TITLE OF PROJECT: Bessey Hall - Chiller Replacement

PROJECT NUMBER: CP23031

ADDENDUM NO: 02

Drawing(s) accompanying this Addendum include: Revised drawings sheets S1.01, M1.01, M2.01, M2.02, M2.03, M2.04, M2.05, M5.01, M5.02 and M6.03.

**BASEMENT PLAN - MECHANICAL DEMOLITION**  
**M1.01**  
 2 OF 27

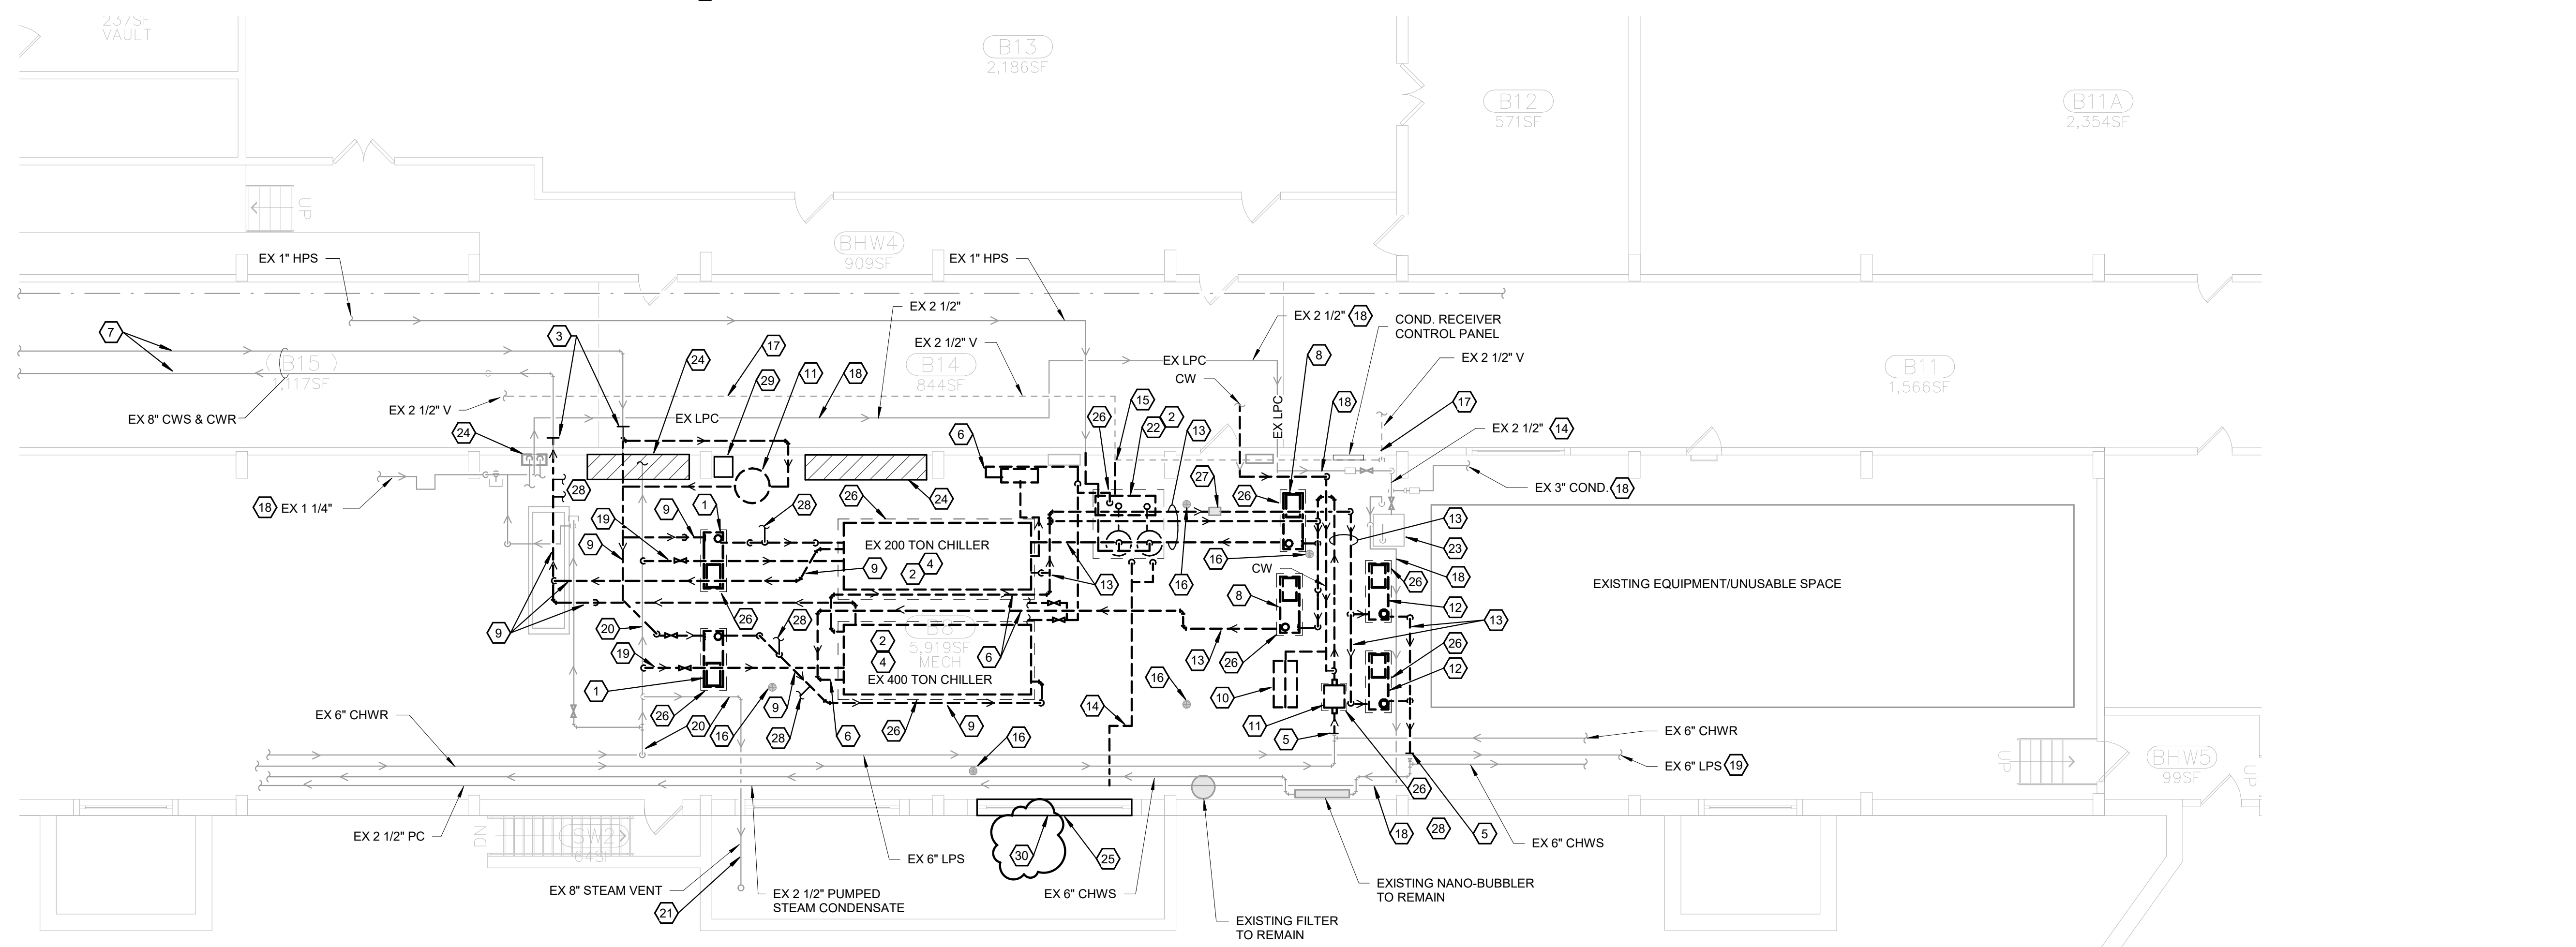
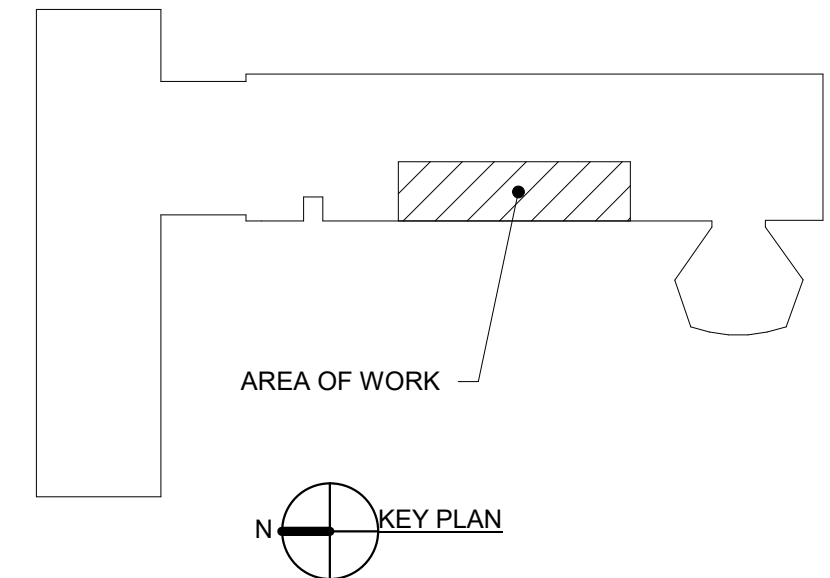
<u>ITEM NO.</u>	<u>DESCRIPTION</u>
01	Updated Drawing S1.01 a. Updated steel information and notes
02	Updated Drawing M1.01 a. Updated general notes b. Updated keyed notes
03	Updated Drawing M2.01 a. Updated general notes b. Updated keyed notes c. Updated water softener piping d. Updated refrigerant monitoring sensors
04	Updated Drawing M2.02 a. Updated keyed notes
05	Updated Drawing M2.03 a. Updated keyed notes b. Updated ice tank layout and piping
06	Updated Drawing M2.04 a. Updated keyed notes

**ICE TANK INSTALLATION DETAIL**  
NO SCALE

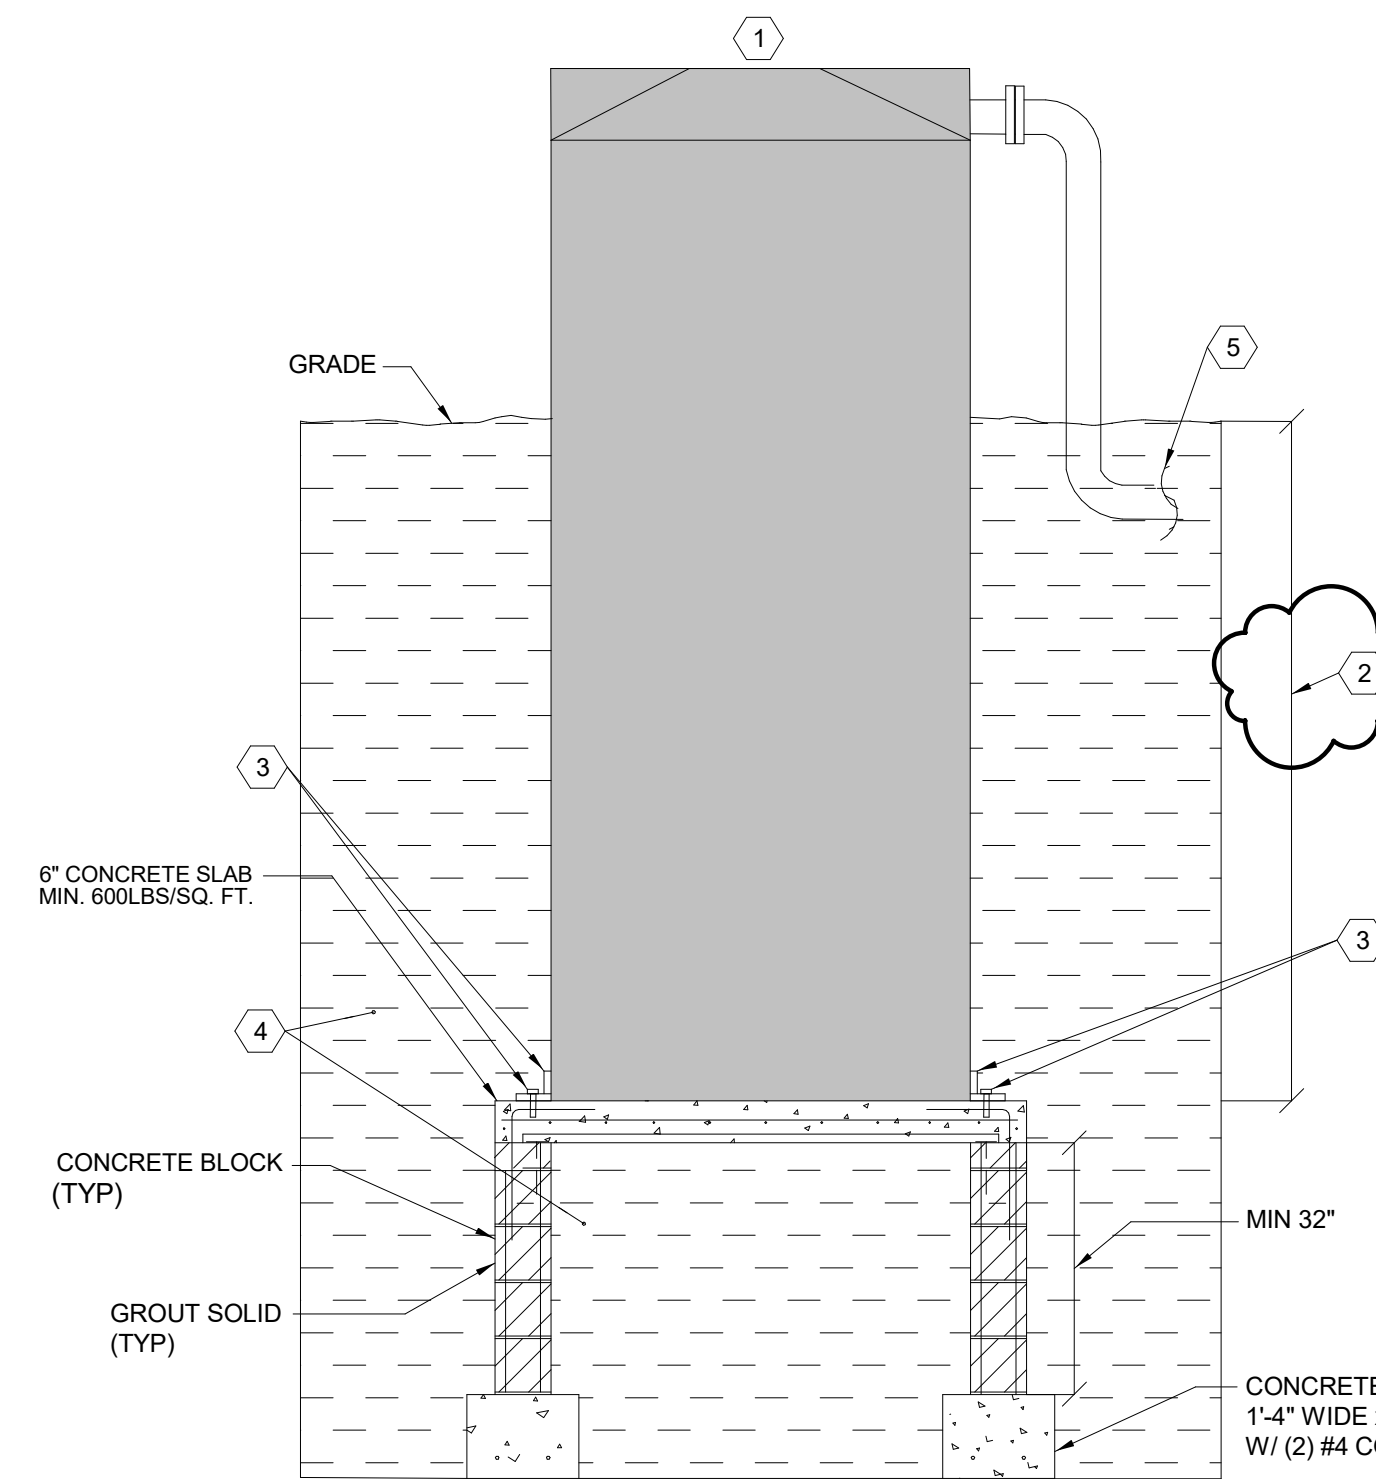
- 10 Updated Drawing M6.03
  - a. Updated ice tank detail

- 1 TOP ACCESS AVAILABLE. KEEP ABOVE TOP OF TANK CLEAR.
- 2 ICE TANK TO BE PARTIALLY BURIED AN APPROXIMATE DEPTH OF 42". COORDINATE WITH MSU FOR EXACT DEPTH OF BURIAL AND INSTALL PER MANUFACTURER'S INSTRUCTIONS.
- 3 ICE TANK GUIDES TO BE FASTENED TO CONCRETE PAD WITH STAINLESS STEEL FASTENERS.
- 4 BACKFILL TO BE DONE WITH SAND PER MANUFACTURER'S INSTRUCTIONS.
- 5 ICE/WATER SUPPLY AND RETURN PIPING. REFER TO PLANS.
